### City of Phoenix PLANNING & DEVELOPMENT DEPARTMENT

#### Staff Report Z-75-21-2 February 9, 2022

Automotive service facility

Quick Quack Car Wash Holdings, LLC

Conceptual Building Elevations, South and West Elevations; Source: RKAA Architects, Inc.

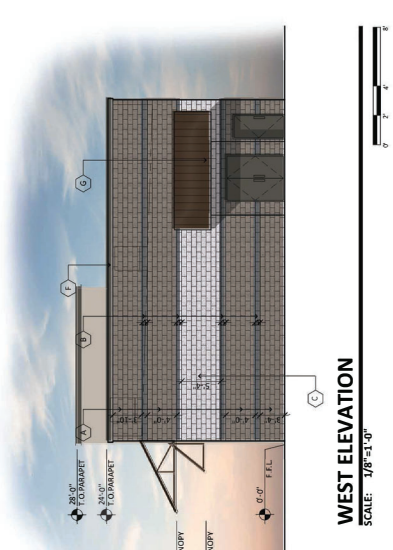
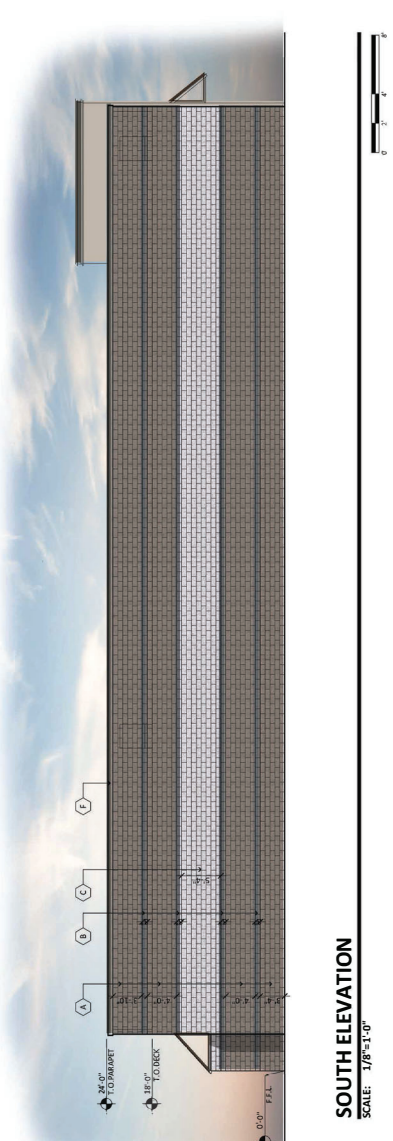
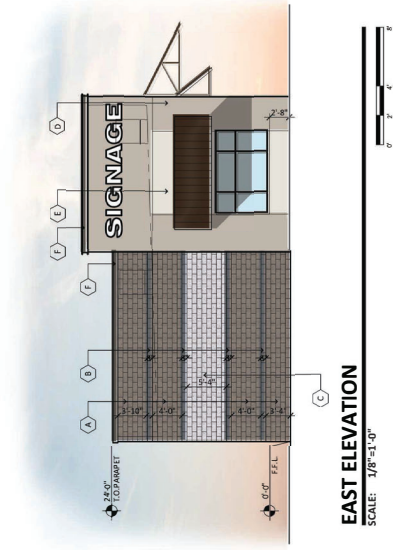
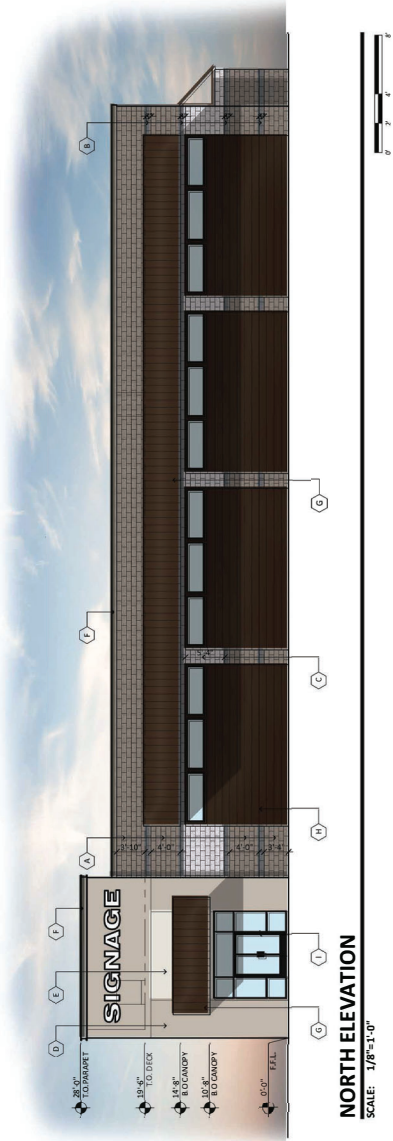
Staff is not recommending general conformance to the conceptual building elevations provided by the applicant because the south and west elevations do not include the same level of finish as the north and east elevations. Staff recommends Stipulation No. 2, to ensure each side of the building contains a minimum of three building materials and contain building enhancements such as detailing or textural changes. Staff is also recommending Stipulation No. 3, to ensure colors and materials are in compliance with the NBCOD to promote consistency with other developments in the Village Core.

1. The development shall be in general conformance with the site plan date stamped November 22, 2021, as modified by the following stipulations and approved by the Planning and Development Department.
2. All elevations of the building shall contain a minimum of three building materials as well as architectural embellishments and detailing such as textural changes,

pilasters, offsets, recesses, variation in window size and location, and/or overhang canopies, as approved by the Planning and Development Department.

3. All buildings, wall colors, and materials shall be in compliance with the North Black Canyon Overlay District with specific regard to colors being muted and blending, rather than contrasting strongly, with the surrounding desert environment, as approved by the Planning and Development Department.
